1	 <b>DEFICIENCY REPORT</b>		<input checked="" type="checkbox"/> FIELD <input type="checkbox"/> OTHER	LDR RESPONSIBILITY M. Herlihy LSU	LDR NUMBER 2507	
2	SYSTEM/COMPONENT Emergency Diesel Gen.	SYSTEM DESIGNATOR 1R43	MARK NO. 1R43*ENG-103	DATE 10/1/84	Q CLASS <input checked="" type="checkbox"/> I <input type="checkbox"/> II <input type="checkbox"/> III	
3	MFG./CONTRACTOR TDI	P.O. 310552	MATERIAL LOCATION Control Bldg. EDG-103	REJECT TAG NO	<input type="checkbox"/> YES <input checked="" type="checkbox"/> NO	
4	SPEC. VIOLATED N/A	DRAWING VIOLATED N/A	PROCEDURE VIOLATED NDE 6.2 para. 4.2.2	CODE/STANDARD VIOLATED		
5	CONDITION DETAILS  Per results of NDE Inspections performed on 1R43*ENG 103 (Cam Galley area) rejectable indications were noted. This is in violation of the LILCO NDE Manual NDE 6.2 (Liquid Penetrant) paragraph 4.2.2 (See attached LILCO OQA Inspection Reports for condition details)

IR43# EDC 103  
MT EXAMINATION INDICATIONS

4103 *msd 9/20/84*  
Diesel Engine 101<sup>A</sup> - Cam Galley Strain  
Gauge NDE Testing  
SHOREHAM NUCLEAR POWER STATION - UNIT 1  
W.O. 44430/48923

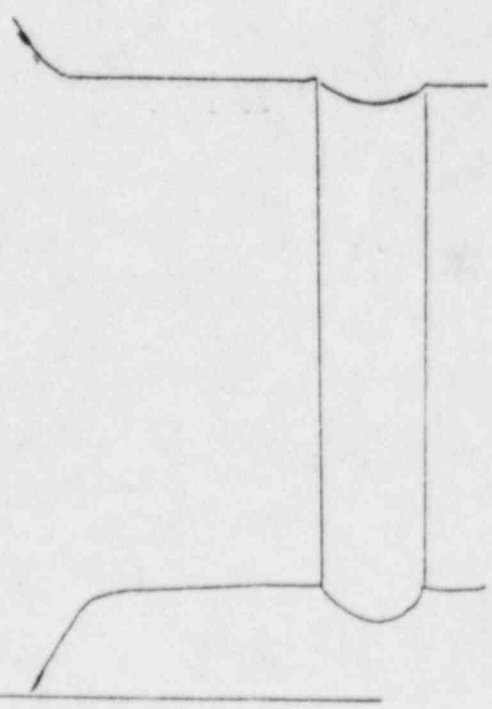
CYLINDER #8

CAM SADDLE AREA

2" LINEAR

2" LINEAR

LP EXAMINATION INDICATIONS

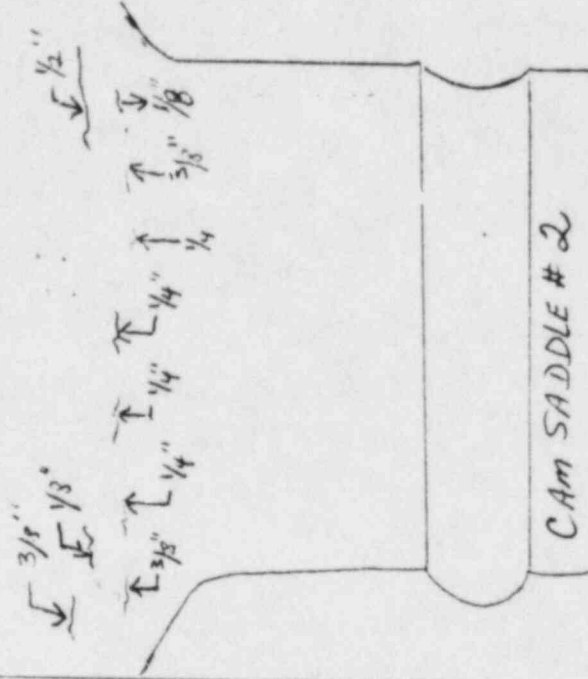
C. EVALUATION		REPORT BELOW THOSE INDICATIONS OBSERVED AND THE PERTINENT INFORMATION REQUIRED. WHERE ADDITIONAL SPACE IS REQUIRED USE OTHER SIDE.			
LOCATION	SIZE (INCHES)	DESCRIPTION	ACTION (ACCEPT/REJECT, AND COMMENT AS NECESSARY)		
1 CAM SADDLE #2	SEE ATTACHED SKETCH OF LINEAR INDICATIONS		REJECT		
2 CAM SADDLE #8	SEE ATTACHED SKETCH OF LINEAR INDICATIONS		REJECT		
3 N/A	N/A	N/A	N/A		
4 N/A	N/A	N/A	N/A

CAM SADDLE #2

LP EXAMINATION INDICATIONS

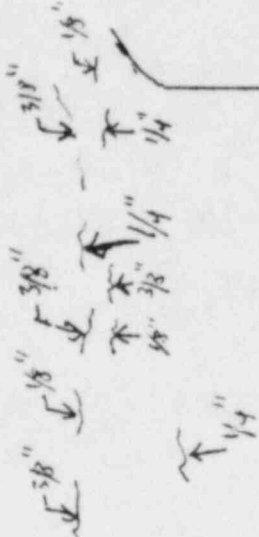
3/8"

2"

CAM SADDLE # 8
